RE: ADDITIONAL INFORMATION DA19/0649

We are writing in response to Council's request for additional information in respect of Concept DA19/0649 for residential development at 52 Plumpton Rd, Tatton.

Figure 1: Proposed area for dedication as open space and drainage

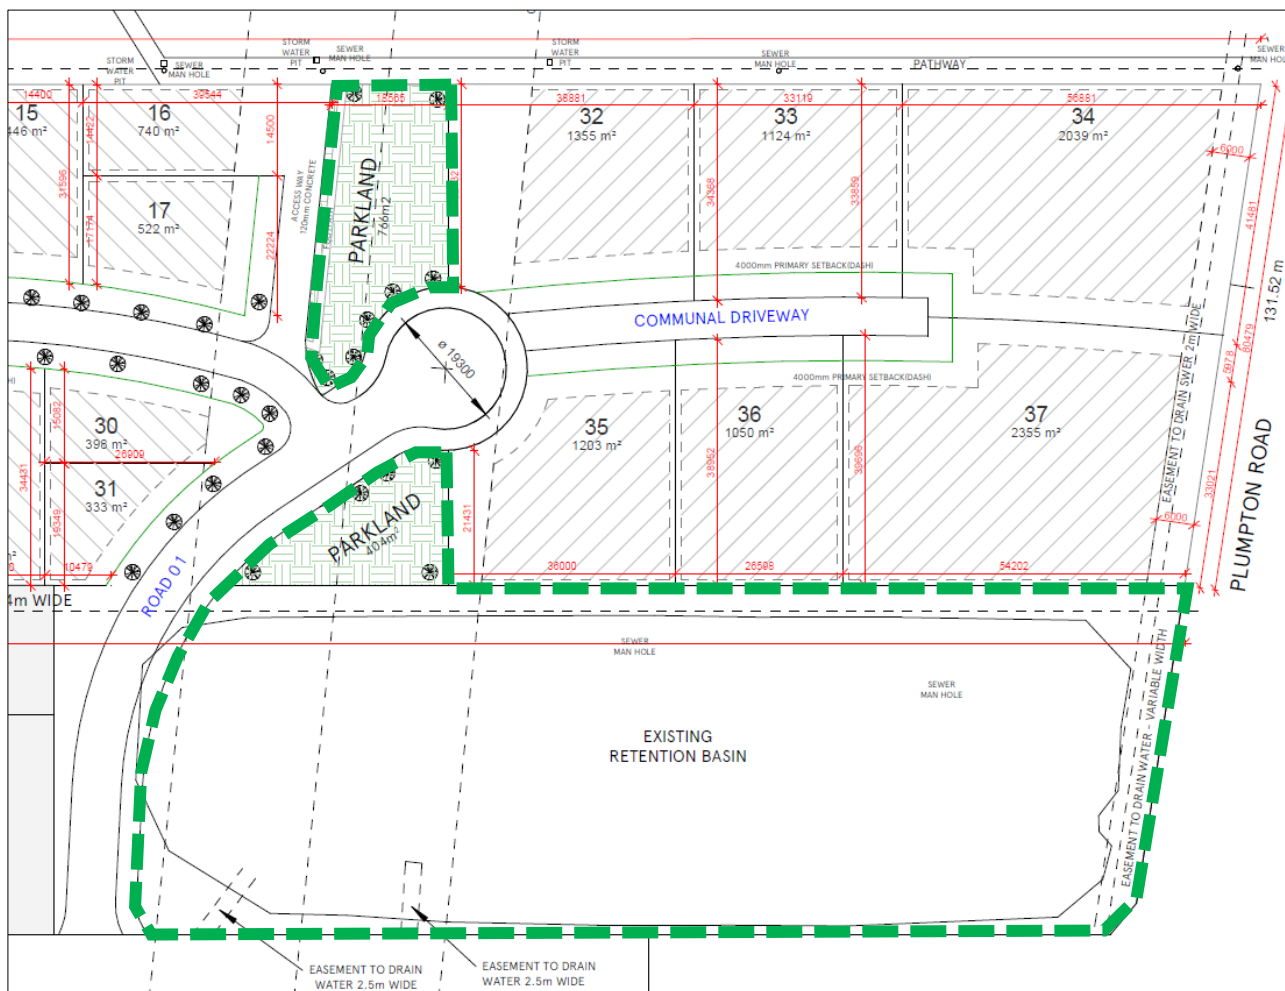
Please provide justification for the open space and demonstrate compliance with the open space requirements and alignment with Council's Recreation, Open space and Community Strategy 2040. More information is required about the future intent of the open space. Will it be dedicated to Council as part of a VPA, noting that there is no allocation within the contribution plans for Council to acquire this land.

Section 2.3.5 of the SEE provides that the dedication of public open space was intended as part of the proposed development. The proposed area is confirmed below. The parkland component comprises 0.117 hectares and would be embellished by the proponent prior to dedication to Council. The drainage reserve comprises approximately 0.82 hectares.

This is justified on the basis that it is consistent with the pedestrian connection indicated between Barrington Street and Brindabella Drive in the South Tatton Masterplan, as indicated below. Council officers have indicated a need for Council to acquire the retention basin and accordingly, this matter has been included in the proposal for land dedication via VPA.

Figure 3: Aerial imagery 1990 (Source: WWCC online mapping, 2020)

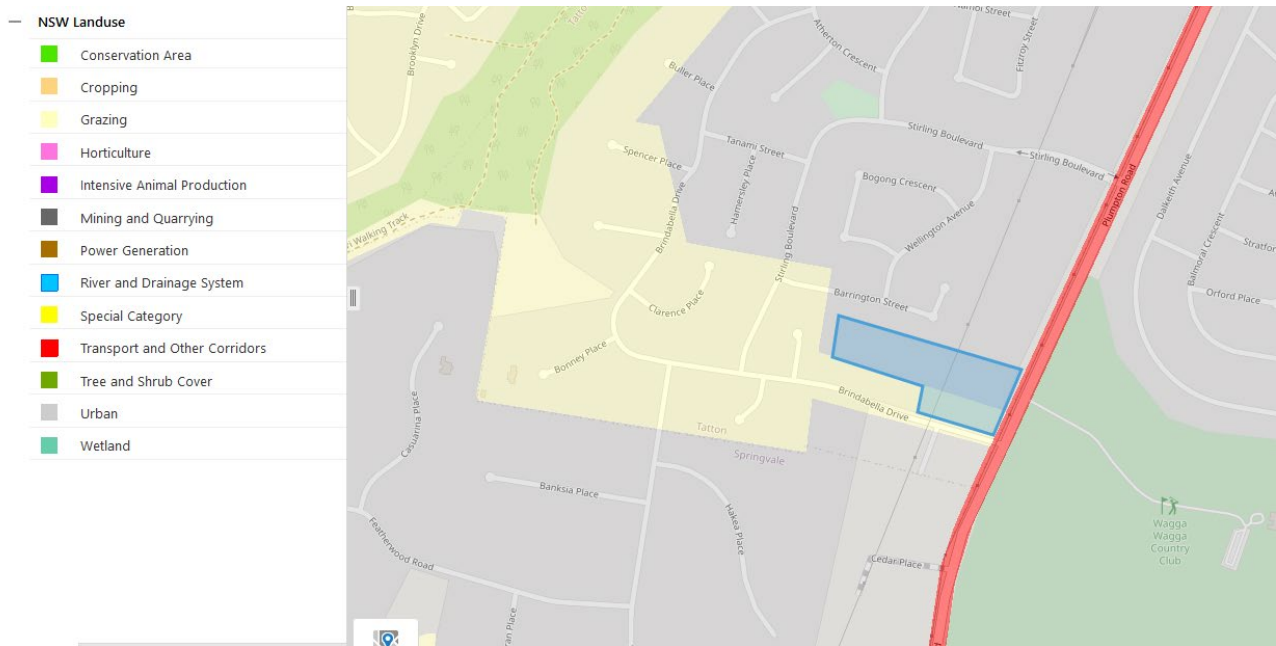
Council's assessment for the rezoning of the land indicated that the subject land has been used for agricultural uses in the past. This land use is a use specified in Table 1 of the Contaminated Land Planning Guidelines. Given the previous land uses on the site (being grazing), it is considered that the potential impacts of Land Contamination are low and a detailed assessment may be undertaken as part of any future application for subdivision and/or land use change. Please provide a certified Detailed Site Investigation (DSI) prepared in accordance with Council's Contaminated Land Management Policy, the SEPP 55 Guidelines —Remediation of Land and relevant NSW EPA and NEPM Guidelines.

Site investigations indicate the land has only been used for grazing. There is no publicly available information to suggest the land has been used for any other activities. Aerial imagery dated 1971 from Council's online mapping indicates a small number of rural dwellings within the Tatton locality. The precinct appears to be mostly used for grazing. Some smaller areas of cropping are identifiable. No industries or intensive plant or animal agriculture or other potentially contaminated uses or activities are apparent on or near the subject land.

Aerial imagery from 1990 indicates the number of rural dwellings within the Tatton locality had increased from 1971, though rural character remains evident. By 1990, the subject property was approximately 7 hectares in area. The subject land appears to be used for grazing, as does surrounding holdings. No industries or intensive plant or animal agriculture or other potentially contaminated uses or activities are apparent.

Our investigations show the subject land has only been used for grazing. The above referenced information indicates the subject land and surrounds have historically formed part of a low-density rural living precinct. Since 1970, the precinct remained rural in character, though density gradually increased. Urban development has occurred in the last 20 years.
